**Southwest Florida Water Management District
Draft Response to the Initial Peer Review of the
Recommended Minimum Flows for the Little Manatee River,
September 2021 Draft Report**

June 2023

Southwest Florida Water Management District
Brooksville, Florida 34604-6899

Figure 4-1. The Biological Condition Gradient Model (from Davies and Jackson 2006).

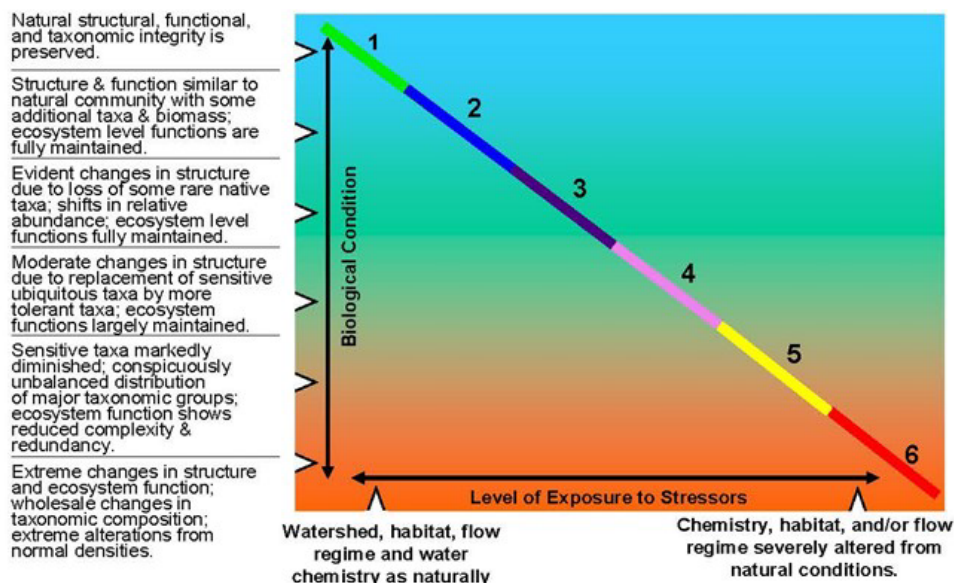
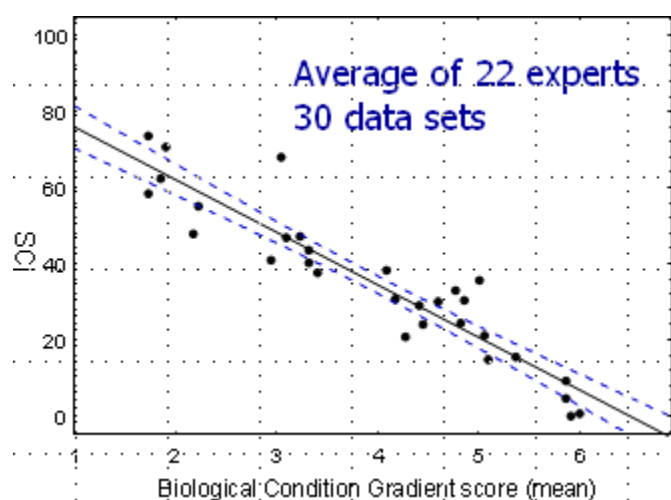
The six levels described above can be used to correlate biological index scores or other management tools with biological condition, as part of calibrating an index or assessing the management decision (Figure 4-2). Once the correlation is established, a determination is made as to which biological condition represents attainment of the Clean Water Act goal according to Paragraph 101(a)(2) related to aquatic life use support, “protection and propagation of fish, shellfish, and wildlife”, or in the case of minimum flows development, protecting against significant harm. Many groups of experts have provided opinions that human activities should not cause the biological condition to drop more than two categories, and in no case should anthropogenic activities reduce the condition to less than 4.

Suggestion: **For future minimum flows development studies**, District scientists should assess how much the BCG gradient category of the waterbody in question would be reduced at the 15 percent reduction threshold for determining significant harm compared to baseline conditions. Perhaps the BCG approach can provide an

District Response: District staff appreciate the comment and will consider using the BCG approach in the future to provide an additional method supporting the 15 percent reduction threshold when determining significant harm.

Figure 4-3. Model grid overlain onto aerial photography.

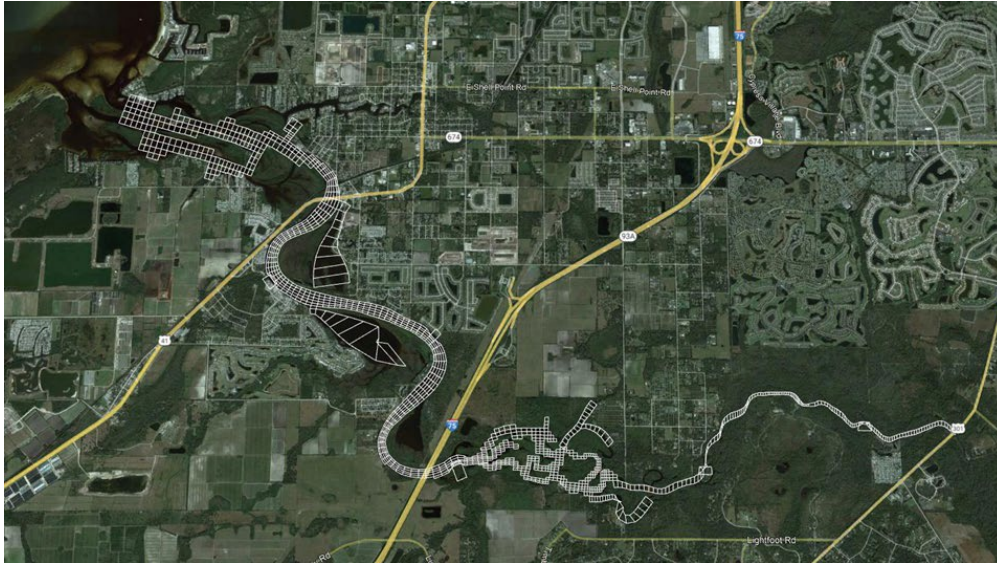
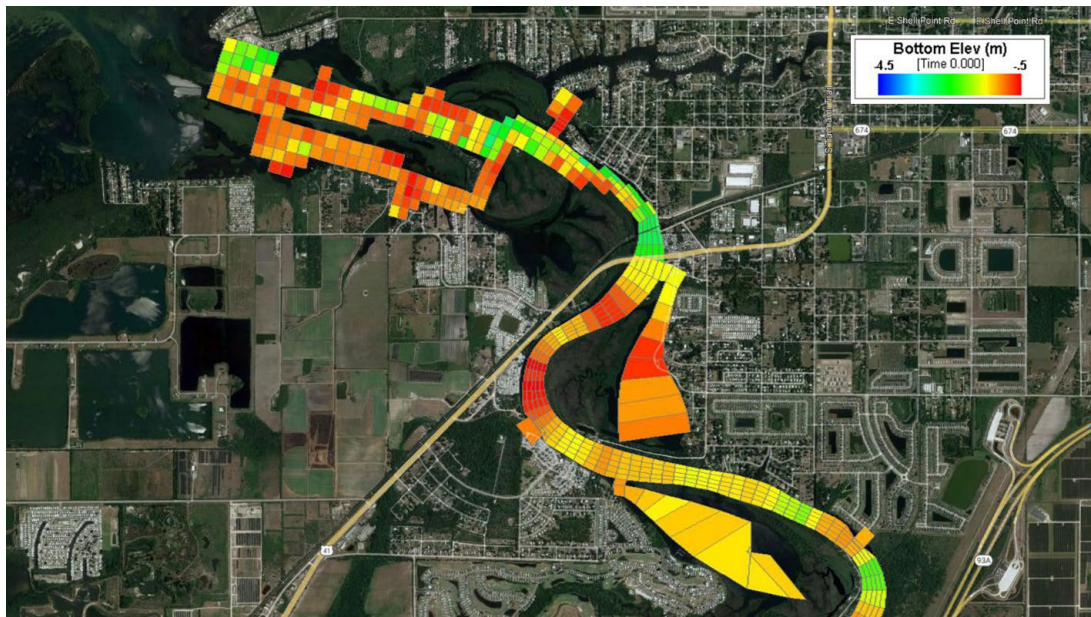
For mechanistic models of this type, a key aspect is that the grid developed provides a reasonable and accurate physical representation of the system. Figure 4-3 presents the EFDC model grid overlain onto an aerial of the estuarine portion of the Little Manatee River. The program utilized to transform the available model input files into a representation of the grid in some areas is not completely accurate, but overall, the recreated grid represents what is in the model.

Examination of the grid in relation to the shoreline of today shows areas where the physical representation does not match the actual conditions horizontally. This is especially evident in the area between the mouth up to US Highway 41. This can be seen in the figure as well as in the original grid plots presented within the Huang and Liu report (2007). In this area, the sinuosity of the channel is not represented. Upstream of US Highway 41 while the grid does generally follow the primary river channel, the grids extend outside of the channel into tidal marsh areas and in some instances upland areas. Figure 4-4 presents the depths as represented in the model. Examination of this figure identifies that the model, in a number of areas, is flat across the cross sections with no true channel geometry defined. This is most likely not an accurate representation of the overall system geometry.

One aspect of the model is that there is no wetting and drying being simulated. Examination of the model input files indicates this function is turned off. Wetting and drying is where the model simulates areas of tidal marsh that flood and drain throughout the tidal cycle.

Examination of the aerial photographs indicates there are potentially significant areas of tidal marsh adjacent to the system. While the model does include some side storage areas, it would appear that overall, a number of areas are not being simulated. This would relate to the accuracy of the tidal prism being simulated.

Recommendation: The model is utilized to calculate area and volume changes, so an analysis should be conducted to provide a comparison of the model areas and volumes with the actual volumes and areas in the system. A recommendation would be to calculate the longitudinal cumulative volume and area from the river mouth in the model (by river mile) up to US Highway 301 versus actual inundated volume and area calculated from available shoreline, LiDAR, and bathymetric data. This should include adjacent tributaries as well as potential areas for flooding and drying in the adjacent marsh areas.

District Response: Comparisons of cumulative volume and area for the updated EFDC model, including adjacent tributaries, are included in an appendix (JEI 2023) of the revised draft report. The updated model also simulates wetting and drying. The slight over-representation of the river width in the upstream area of the Lower Little Manatee River was corrected in the post-processing when salinity habitats were calculated.

Figure 4-5. Measured Surface and Bottom Salinity Boundary Condition.

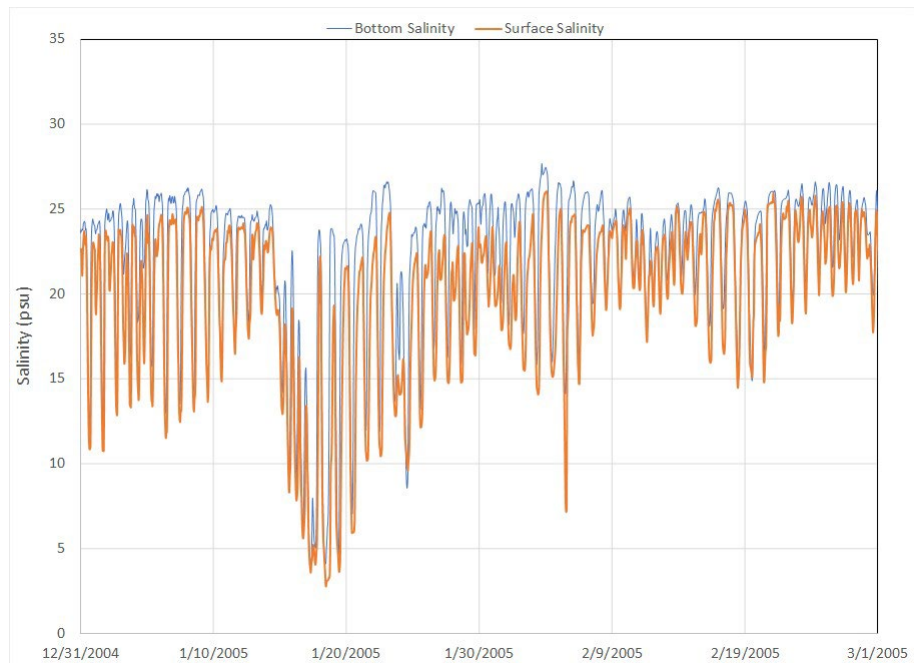
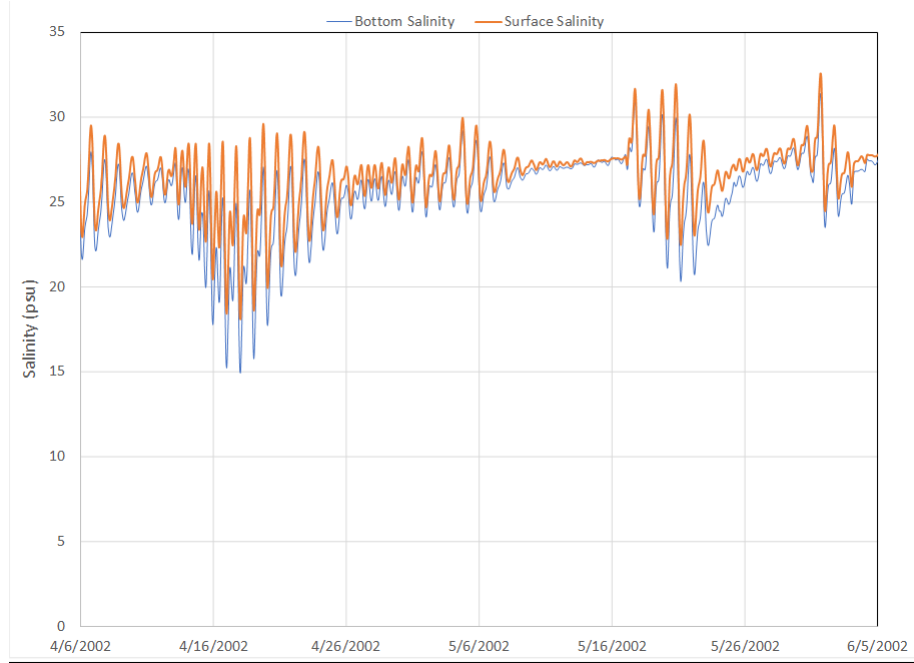
For the baseline run and the flow reduction runs it was determined that the boundary conditions in the model are a mixture of measured data (for the period from around March 2004 through 2005) and data generated from regressions developed by HSW. This was not documented in any of the supporting materials. Figure 4-5 presents a plot of the surface and bottom salinities for 60 days where the measured data were utilized. Figure 4-6 presents a plot of the surface and bottom salinities where the boundaries were derived from the HSW regression. Examination of the plots shows two things. First, it appears for the boundaries created using the HSW regression, an error was made, and the bottom and surface salinities appear to have been flipped. Second, the overall behavior of the boundary in the regressed condition does appear to match that seen in the measured data. It should be noted that for the minimum flows development, the HSW regressions were updated and per the documentation provided improved.

Recommendations: Runs should be performed to determine if the error is fixed if it would change the results of the simulations. It is likely that this error will not have a significant impact on the overall calculations due to the generally small degree of stratification in the system, but the District must determine the defensibility of carrying this error forward if the analyses are not fully redone with the fixed boundary condition. Additionally, the regression utilized for the generation of the boundary conditions should be utilized to calculate the boundary condition during the period of the measured data and the two compared. This will allow for an assessment of the reasonableness of the created boundary for MFL determination.

District Response: This problem does not exist in the new EFDC model simulations. The salinity boundary conditions in the updated model are from another hydrodynamic model for Tampa Bay and not from the HSW regressions.

Figure 4-7. Comparison of original least squares regression to update LOESS regression.

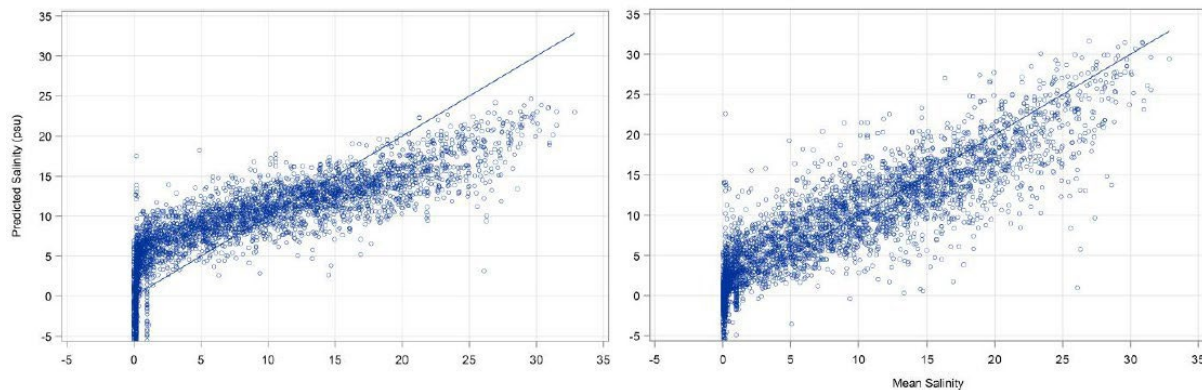
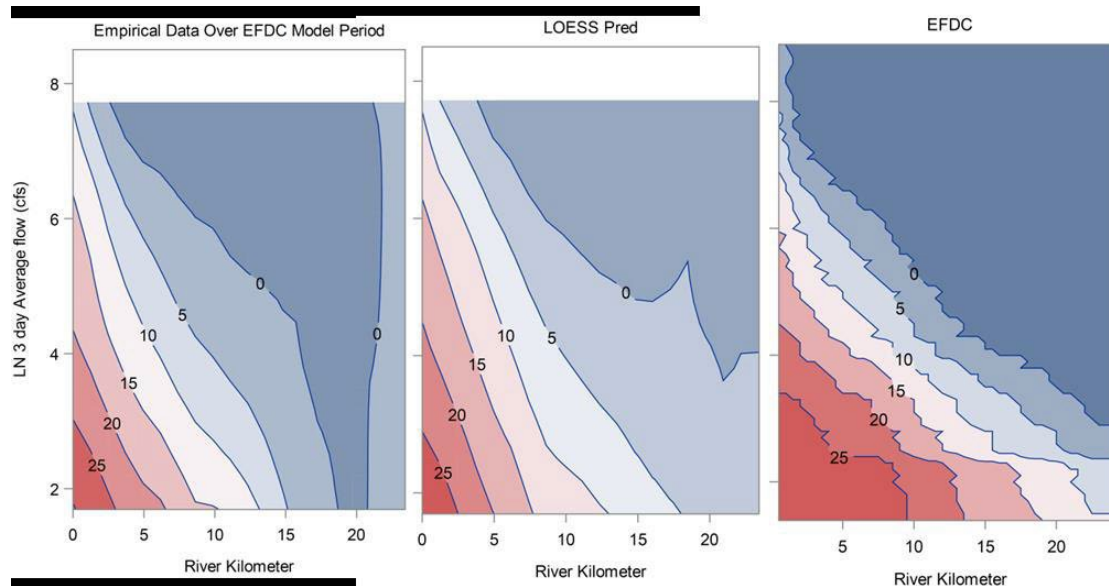
Examination of plots presented in the main document and appendices provides a demonstration of the accuracy of the regression model under various flow conditions. Figure 4-7 below presents a plot of the final regression against the available data (right) versus previous regressions prior to the update. The plots show that the updates to the original regressions represented a significant improvement. Examination of the results does show that the revised regression has somewhat of an overprediction bias at the lower salinity levels and somewhat of an underprediction bias in the upper salinities. Figure 4-8 presents comparisons of the salinity projection contours under different flow conditions and location along the river. The results show that the regression model does well in representing the conditions along the overall flow gradient and longitudinally and in some aspects provides a more accurate representation of the data than the EFDC model. Based on the evaluation of the model, the determination is that the regression (within some of the limitations of this type of regression modeling) is sufficient for use in the development of minimum flows.

District Response: District staff appreciates the comment. Note that the revised draft report includes updated EFF analyses.

Figure 4-10. Zooplankton community heterogeneity in Little Manatee River estuary by flow (top panel) and salinity (bottom panel) (from Peebles 2008).

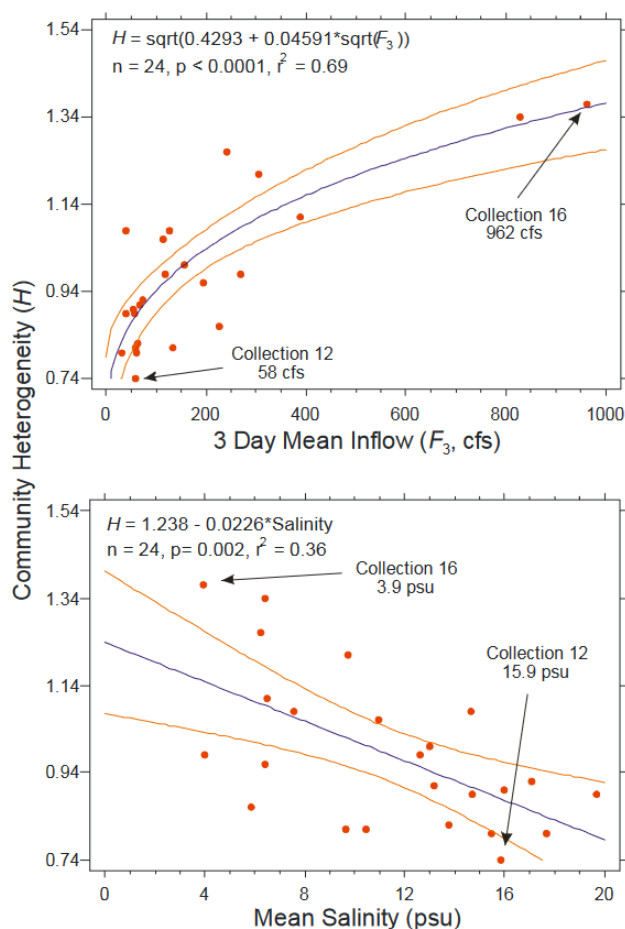
At low to moderate flows, water residence time at the area most likely to support taxa favoring 1-2 psu salinities (Rkm 15-19) ranges from 1 to 5.6 days (Figure 4-9). This indicates that a fairly narrow, transient area exists that is capable of supporting the taxa that require the 1-2 psu salinity range. This short resident time area is critical for the protection of these salinity-sensitive organisms. For example, Peebles (2008) found that the highest community heterogeneity was associated with higher river flows and lower salinities, indicating that this transient, low-salinity habitat is important to protect through the minimum flows development process (Figure 4-10).

District Response: District staff appreciates the comment.

Figure 4-11. Area of inundated vegetation (green) as a function of the percentile flow at the USGS Little Manatee River at US 301 near Wimauma, FL (No. 02300500) gage. The USGS flow gages are shown as red triangles (from JEI 2018).

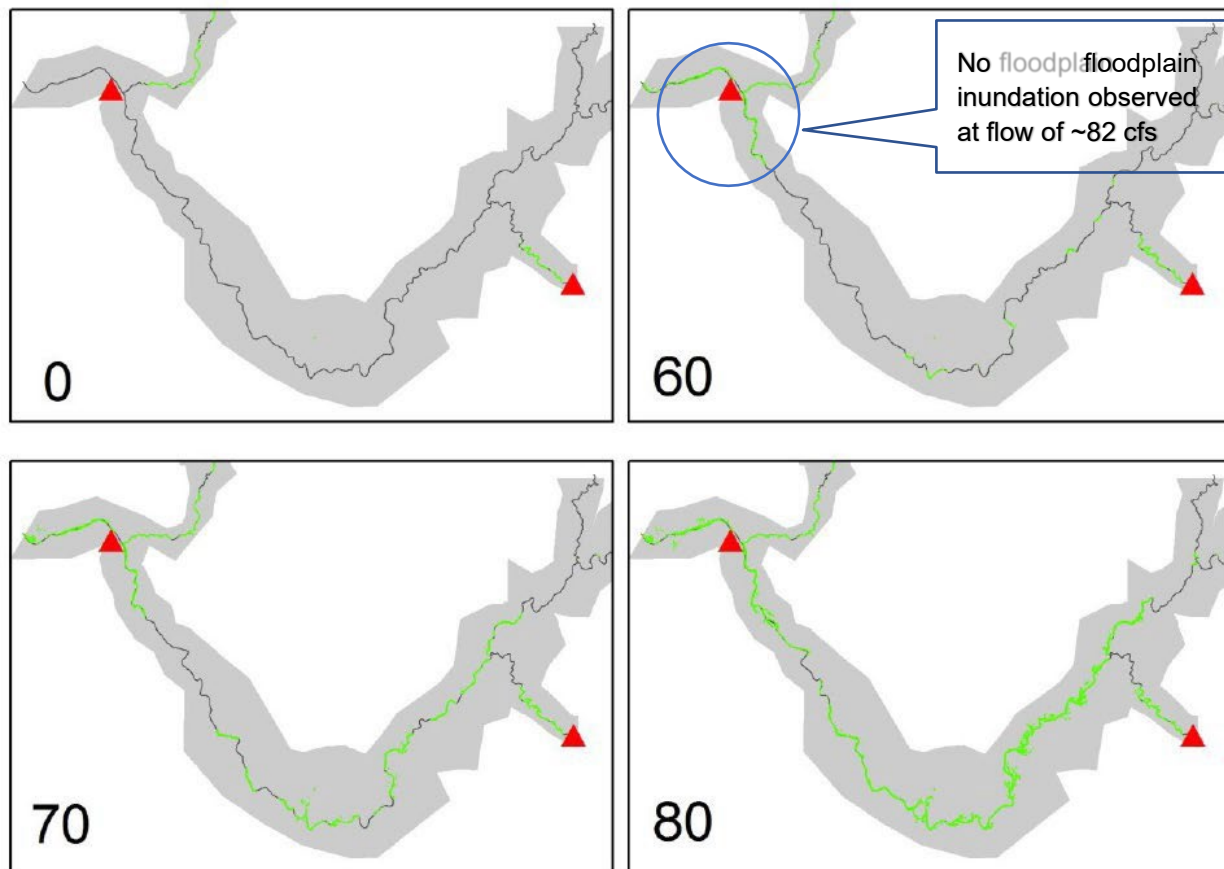
Furthermore, during field observations conducted on October 15, 2021, flow at the USGS Little Manatee River at US 301 near Wimauma, FL (No. 02300500) gage was about 82 cfs, which would be within proposed Block 3. Field observations were conducted at several locations, including the entire area along the main river channel circled in blue in Figure 4-11. No floodplain inundation was observed at any of the visited locations. Flows were fully contained within the banks with significant freeboard suggesting much higher flows would be needed to inundate the floodplain. This raises the question of whether the 60th percentile flow (72 cfs) is properly supported as a high-flow threshold.

District Response: The revised draft report includes an updated floodplain inundation analysis and updated flow blocks for the upper river.
